Appendix 1 : Feasibility Study on Rehabilitation of Da Nhim Power System

Memorandum of Meeting

(2) 散布図 年一設備停止率

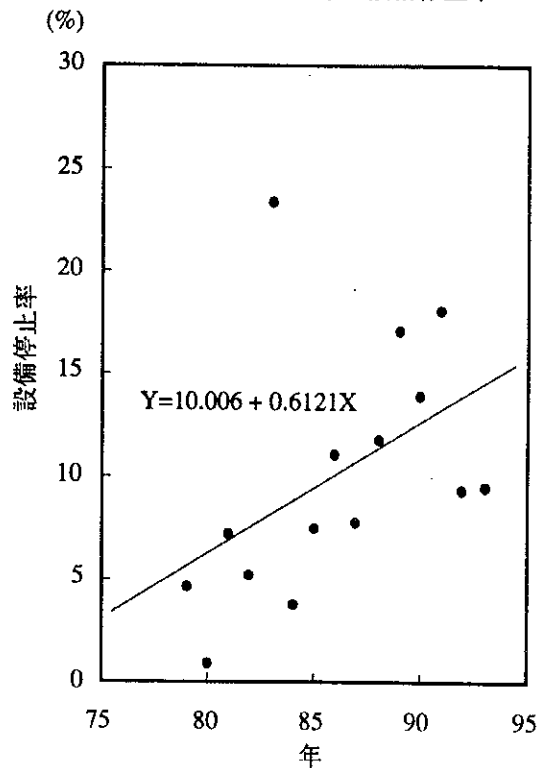
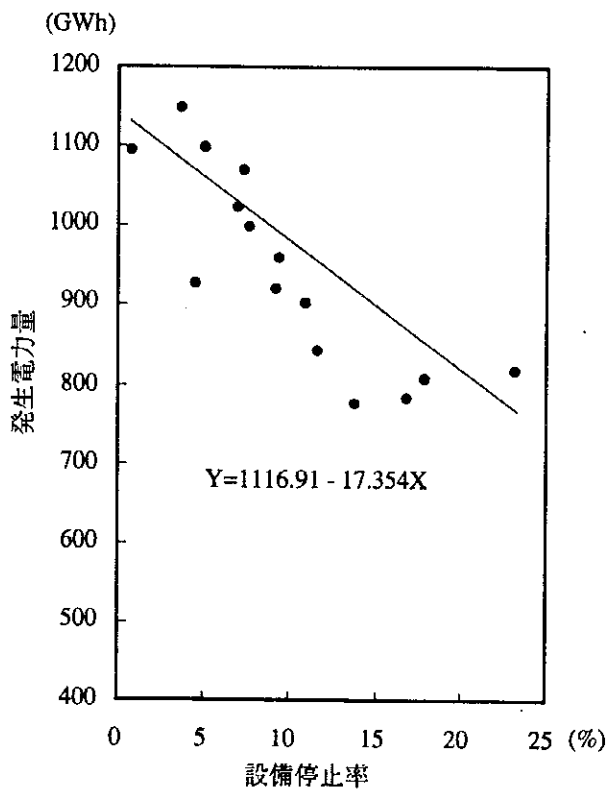
- (i) PC-2 have their concern that the increase of the year - outage factor of the generating equipment from 1975 to 1995 showing on Fig.12.1 was caused mainly from the hydrological condition and power system operation condition in the south of Viet Nam.
- (ii) The formula of the increased energy production after rehabilitation or renewal of the facilities is required to be discussed in detail.
- (iii) Energy unit costs of 0.0561 US\$/kWh for the financial evaluation and 0.07 US\$/kWh for the economic evaluation are required to be discussed.

The study team stated in response to the above item (i) that the cause of the outage of the facilities was estimated on the basis of the assumption as referred to paragraph 2 of page 12-2 of the report.
